TSB-AG01

FLYWHEEL MODIFICATION REQUIRED TO SUIT CLUTCH DISC 335 1601 RE-DCB

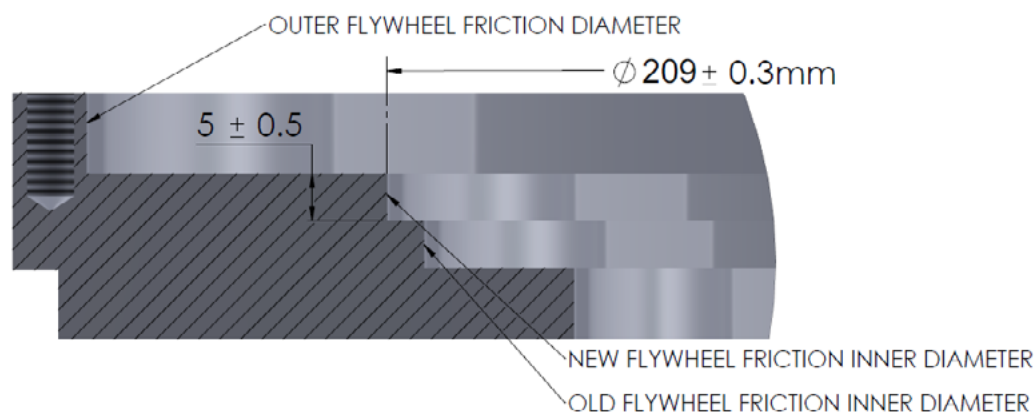
Re-Machine the inner recess of flywheel to a diameter of 209mm and a depth of 5mm to avoid clutch disc rivets contacting flywheel.
